ORDINARY MEETING OF COUNCIL

6.3	Subdivision (1 into 2 lots), dwelling & outbuilding located at 183 Back Cam Road, Somerset - SD2144 & DA 215/2021	
Enclosure 1	Consolidated advertised documents.....	2
Enclosure 2	Representation	114
Enclosure 3	Updated bushfire report & plan.....	116
Enclosure 4	Signed extension of time	155
9.1	Declaration of Office	
Enclosure 1	Certificate of Election 2022	156
9.6	Financial Report For the Period Ended 31 October 2022	
Enclosure 1	Monthly Capital Report - October	157
9.7	Senior Management Report	
Enclosure 1	Waratah_Wynyard Request for Finfish Farming Public Forum	164
Enclosure 2	2022/23 Councillor Allowance Payments Information Sheet.....	165
Enclosure 3	2022 11 04 - NRM Response to Request for Public Forum on FinFish Farming	168

SD 2144 & DA 215/2021 183 Back Cam Road SOMERSET

Proposal: Subdivision (1 into 2 lots) & Dwelling and Outbuilding (Shed)

CLASSIFICATION

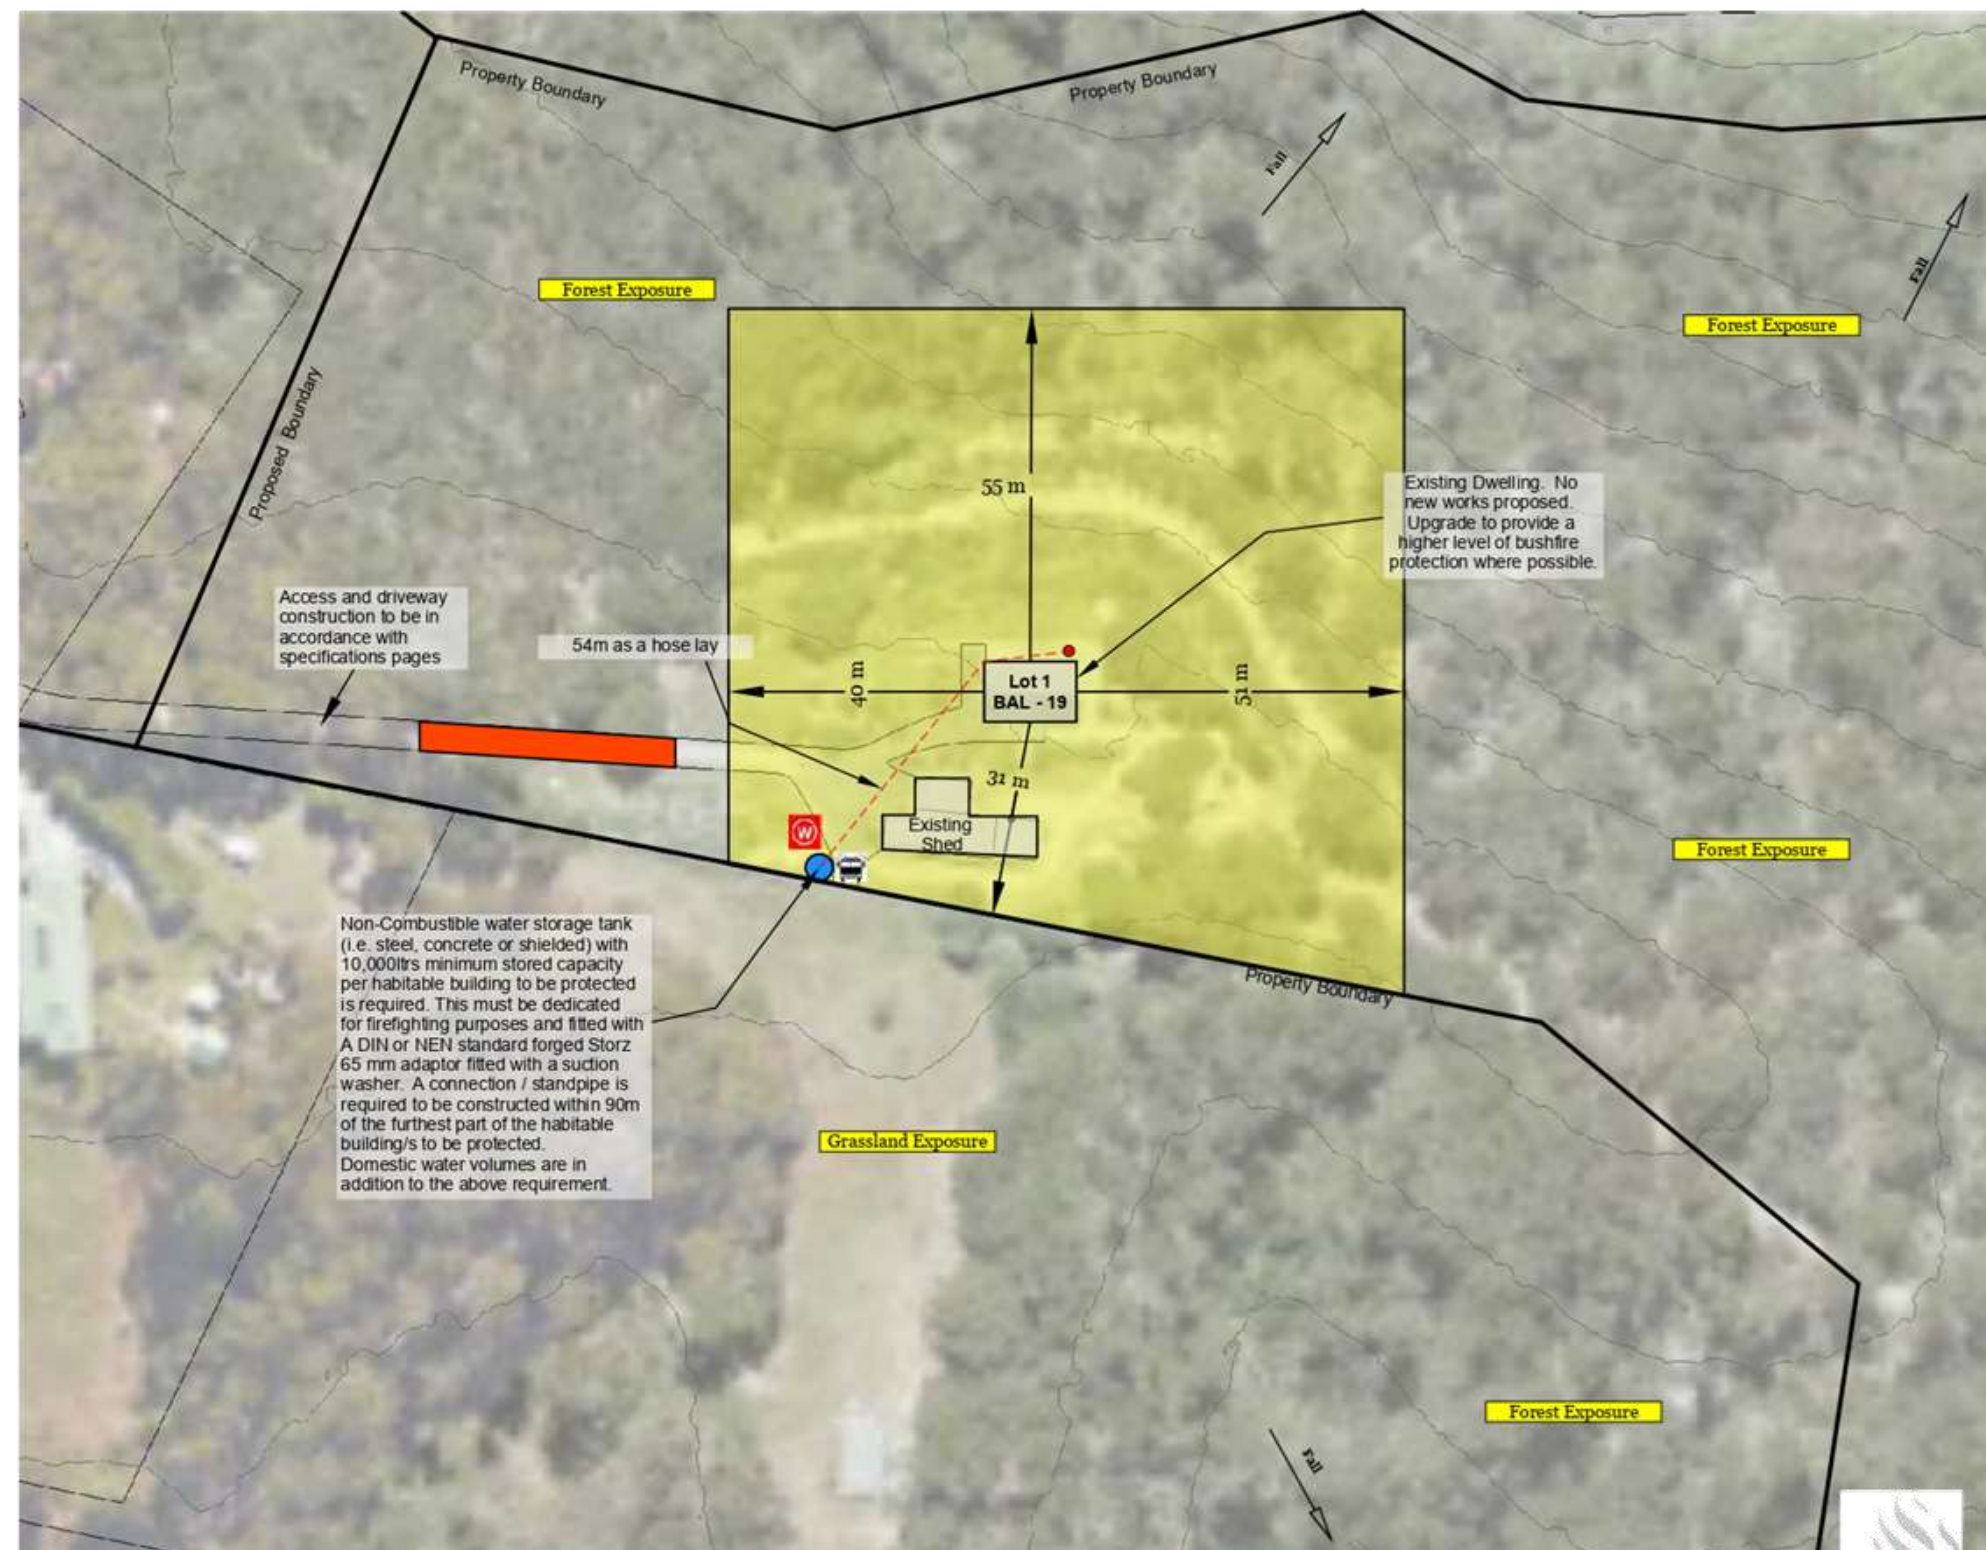
1. E1.6.1 – We believe that the slope assessment is significantly incorrect. The EnviroPlan report assesses the lot 1 slope to north at >10-15 degrees, our TFS assessment has it well in excess of 30 degrees, therefore the hazard management area dimensions are inadequate, not providing for BAL-19 as required by E1.6.1. This is a much greater fire risk to the site and occupants than assessed by the report.
2. As a result of this incorrect assessment, the application doesn't adequately identify the required vegetation removal. The likely true scale of required vegetation removal will be much more than is indicated.
